ASSESSMENT REPORT

Section 75W Modification Morisset Park Residential Development (MP08_0014 MOD 1)

Figure 2: Location of the Intersections Affected by MP08_0014 MOD 1

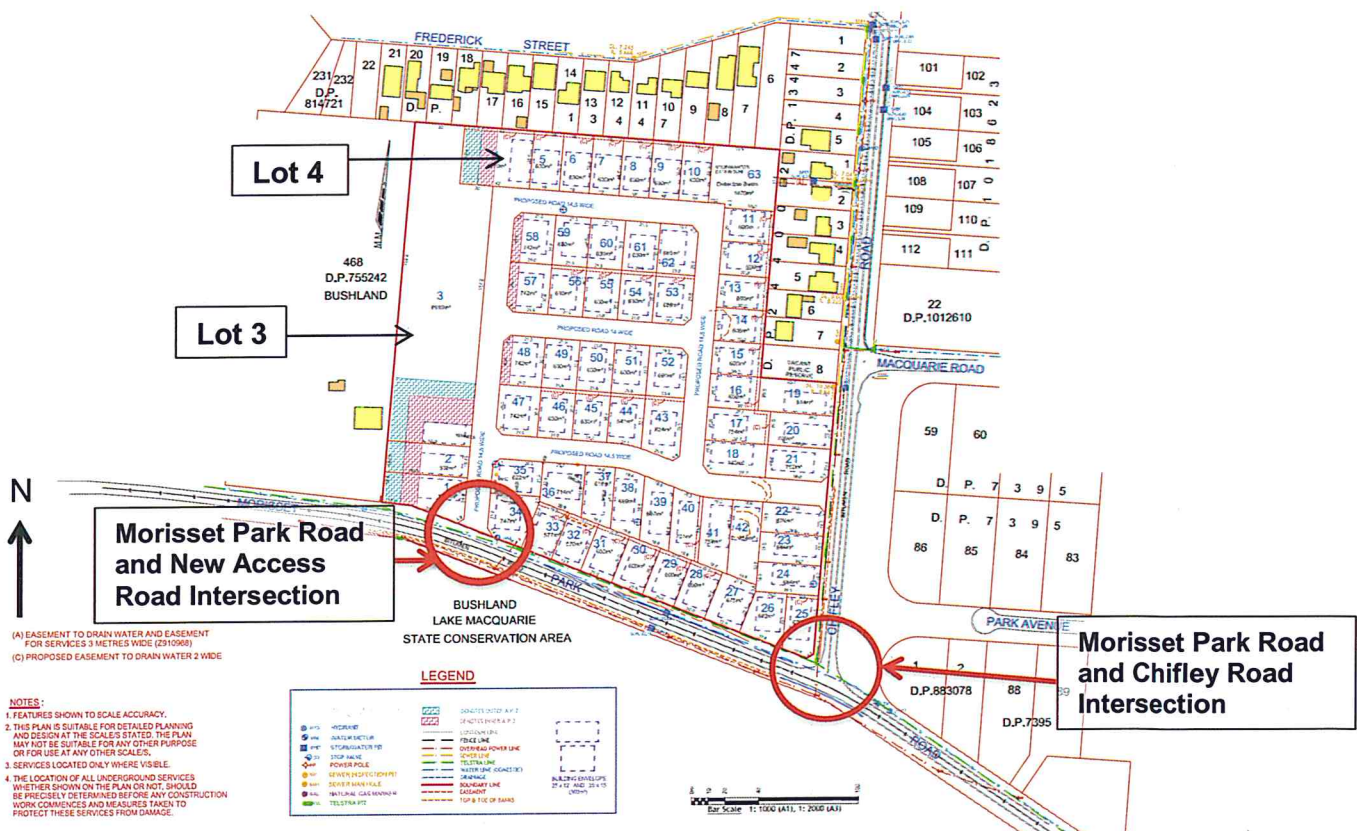
In July 2014, De Witt Consulting (the Proponent) lodged a section 75W modification seeking approval to revise the road design requirements for the Morisset Park Road/Chifley Road intersection and the Morisset Park Road/New Access Road intersection (see **Figure 2**). On 20 October 2014, the Proponent sought to further modify the application to re-word Condition B1 to correct an administrative error relating to the location of the APZ for Lot 4.

The Proponent has advised that the modification is required to ensure compliance with the current Austroad guidelines, which no longer require the construction of auxiliary right turn (AUR) intersections along Morisset Park Road as specified in Condition B9. The current intersection requirements are discussed in greater detail in Section 4 of this report.

Figure 3: AUR (Approved) and BAR (Proposed) Treatment

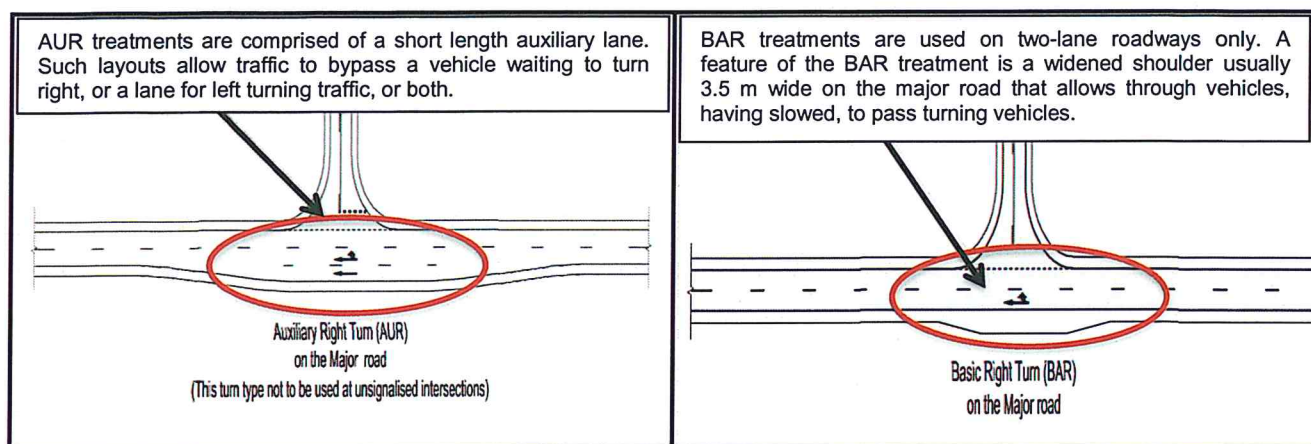
The Department notes that Condition B9 of the Project Approval requires the Proponent to construct AUR intersections along Morisset Park Road to ensure compliance with *Austroads Part 5 2005*.

Following approval of the application, the *Guide to Road Design – Part 4A: Unsignalised Intersections* (2010) was released by Austroads. The current guideline does not support the use of AUR intersection treatments on the basis that the additional turning lane required for an AUR intersection is often mistaken for an overtaking lane, resulting in an increased incidence of vehicular accidents where this treatment is applied.

Based on the traffic volumes predicted in the original Project Application, the Proponent considers that a basic right turn (BAR) treatment is required for both intersections along Morisset Park Road to

facilitate compliance with the current Austroad guidelines. **Figure 3** below identifies the difference between design of AUR and BAR intersection treatments.

The Department has assessed the proposed modification in consultation with the Council and the RMS and agrees that it is no longer appropriate to require the proponent to construct AUR intersections along Morisset Park Road. Furthermore, the Department considers that the construction of a BAR intersection will provide a superior road safety outcome along Morisset Park Road which is capable of modification in the future should traffic volumes increase as a result of development occurring on adjoining sites.

Accordingly, the Department supports the modification of Condition B9 to permit the construction of BAR geometric intersections along Morisset Park Road. However, the Department notes that Condition B9 does not specify when the intersection and road upgrades will be constructed. The Department has amended the condition so that the road and intersection upgrades are constructed prior to the issue of the Subdivision Certificate. The Department discussed the proposed timing of the road works with the Proponent and Council and both parties advised that they were satisfied with the revised condition.

Figure 4: Location of IPA and OPA for Lots 3 and 4.

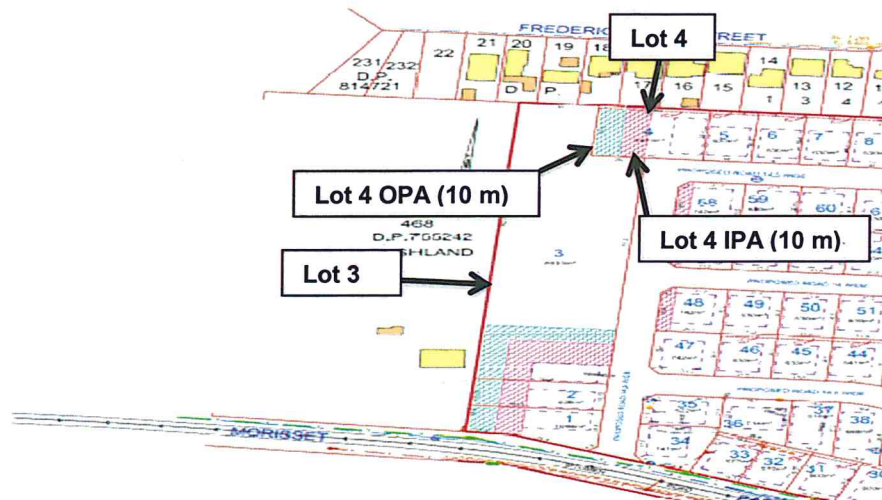
In its assessment of the original Project Application, the Department noted that the APZ for Lot 4 encroached into Lot 3. In order to ensure the appropriate long term management of the APZ for Lot 4, the Department imposed Condition B1 which requires the boundary of Lot 4 to be extended by 10 m in a westerly direction, therefore increasing the size of Lot 4 to 1,120 m² and reducing the size of Lot 3 to 9,260 m².

APZs consist of both an inner protection area (IPA) and an outer protection area (OPA). The management requirements for these protection areas vary depending on slope, vegetation, the fire danger index and finished floor levels. The APZ requirement for Lot 4 is 20 m, which is comprised of an IPA of 10 m and an OPA of 10 m (see **Figure 4**).

The Proponent has indicated that there is an error with the calculations in Condition B1. In order to enable the OPA to be contained wholly within Lot 4, the boundary of Lot 4 would need to be moved 20 m in a westerly direction, and not 10 m as referenced in Condition B1.

Given the above, the Department supports the re-wording of Condition B1 to increase Lot 4 to 1,470 m² and reduce Lot 3 to 8,910 m² to ensure that both the IPA and the OPA are included in Lot 4 as originally intended by the condition.
